May 24, 2019

Regarding: Baker Creek Hydrologic Analysis
McMinnville, OR
PBS Project 71440.000

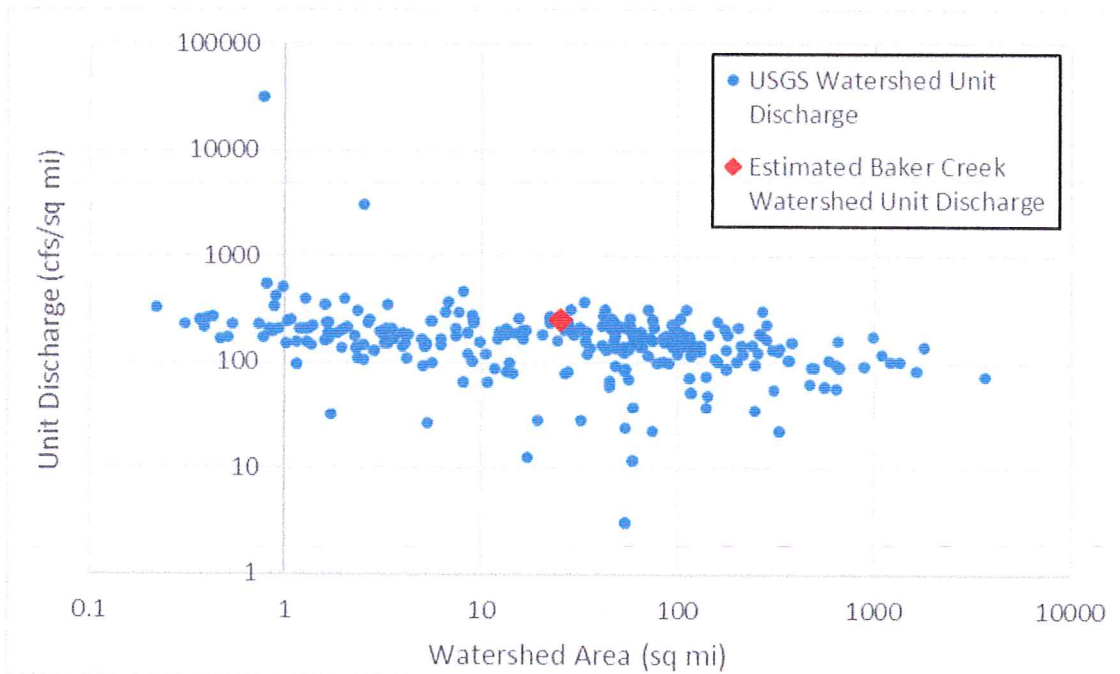
2. **Kellington goes on to claim that the hydrologic model is undermined by the choice of calibration watersheds, providing unit discharges for two of the calibration watersheds (140 cfs per square mile and 154 cfs per square mile for Butte and Tualatin Creeks, respectively)**

Kellington has utilized unit discharge as reasoning to support the implication that a “whopping” 249 cfs per square mile is out of the realm of possibility. What Kellington selectively omits is that the gage statistics for the third calibration watershed (Scoggins Creek) indicate that its 100-year peak unit discharge for that gage is over 230 cfs per square mile, which is very similar to that estimated for the Baker Creek watershed.

Unit discharges are not a reliable way to compare watersheds in isolation. Unit discharge is ultimately influenced by a number of factors, including watershed geometry, soil types, and land cover types. One reason for higher unit discharge occurring in the Baker Creek watershed than in the Tualatin and Butte watersheds is that the calculated curve number parameter is higher than in the other watersheds, which results in a greater volume of runoff from the surfaces in the watershed. It stands out that a watershed with more similar size and calculated curve number parameter, all included in the report, has very similar unit discharge to Baker Creek.

2-year Synthetic Storm Event HEC-HMS Flow Hydrograph Result at the Baker Creek Model's Point of Concentration (Peak Flow ~1,860 cfs).

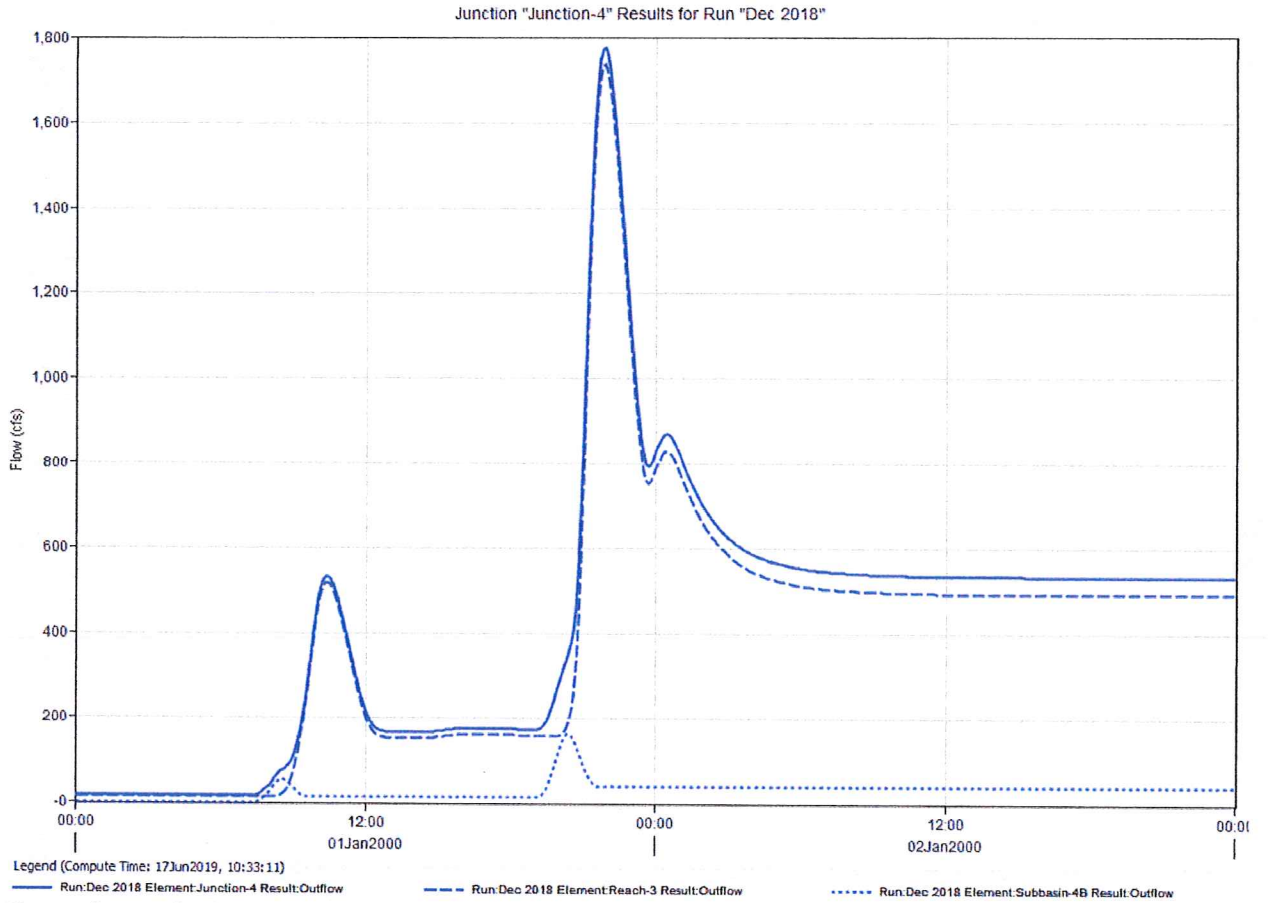
Kellington notes that the report relies for verification on anecdotal photographs that are undated and could have been taken at any time. Kellington states that this "can't be accurate" on the grounds that the "largest 24-hour storm event in November 2015 had a total rainfall for McMinnville airport of 1.53 inches, which is unlikely to be enough rainfall to cause [this] kind of flooding."

In order to illustrate this possibility, 1-hour precipitation readings from the McMinnville Airport gage for December 18, 2018 were input into the HEC-HMS hydrology model in order to roughly estimate peak flow produced by the watershed. The figures below provide the 2-year result first for a synthetic, Type 1A storm event, then for the December 18, 2018 event. This result indicates that peak flow values at the watershed's point of concentration from the two models fall within approximately 5% of one another.

December 2018 Rainfall Event HEC-HMS Model Result (Peak Flow ~1,780 cfs).
